Well Name: HARRINGTON	Well Location: T24N / R1W / SEC 32 / NESE / 36.264688 / -106.959979	County or Parish/State: RIO ARRIBA / NM
Well Number: 7	Type of Well: CONVENTIONAL GAS WELL	Allottee or Tribe Name:
Lease Number: NMSF079352A	Unit or CA Name: HARRINGTON	Unit or CA Number: NMNM073787
US Well Number: 3003905225	Well Status: Gas Well Shut In	Operator: M & M PRODUCTION & OPERATION

Type of Submission: Notice of Intent

Type of Action: Plug and Abandonment

Harrington #7

Proposed P&A

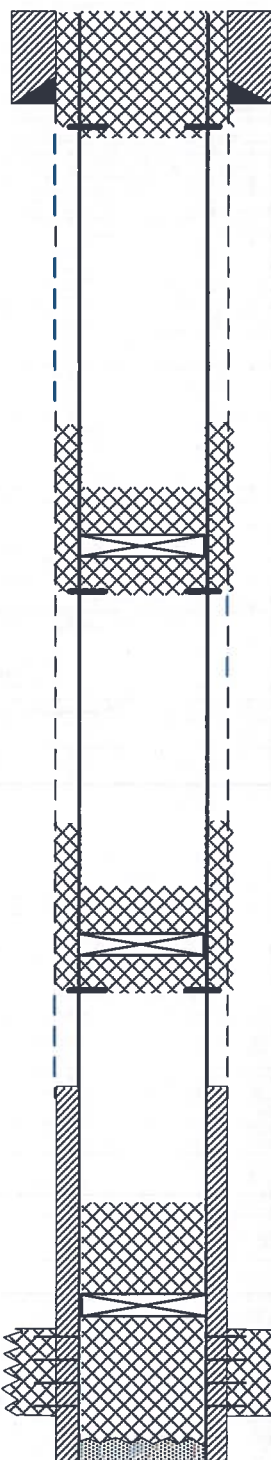
1. Plugging operations must be completed by December 31, 2023.
2. Plugging operations authorized are subject to the attached "General Requirements for Permanent Abandonment of Wells on Federal and Indian Lease."
3. The following modifications to your plugging program are to be made:
 - a. Bring the top of Plug #1 (Pictured Cliffs) up to 2962' to cover Kirtland and Fruitland tops in addition to the Pictured Cliffs.
4. Farmington Office is to be notified at least 24 hours before the plugging operations commence at (505) 564-7750.

- Note: MorningStar Operating, LLC is plugging this well as record title owner of the lease.
- Bring the top of Plug #1 (Pictured Cliffs) up to 2962' to cover Kirtland and Fruitland tops in addition to the Pictured Cliffs.
- Pictured Cliffs perfs 3117' – 3139'.

CICR @ 3,082'
 w/ 6sx cmt on top (TOC~3,005)

PLUG 1 (PC Perfs)
 22 sx cement 3,082' – 3,182'

Estimated and Presumed Current WBD

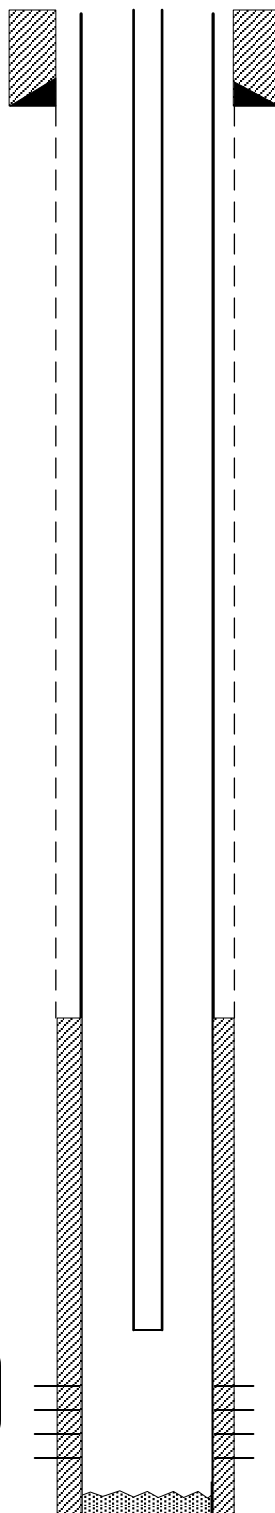
- ii. Estimated TOC here ~ 2,953' or 129' above CICR.
 - iii. Fruitland/Kirtland formation top at 3012', we need 50' above that to have cmt 2962' per BLM COAs.

CICR @ 3,082'
w/ 10sx cmt on top (TOC~2,953)

PLUG 1 (PC Perfs)
22 sx cement 3,082' – 3,182'
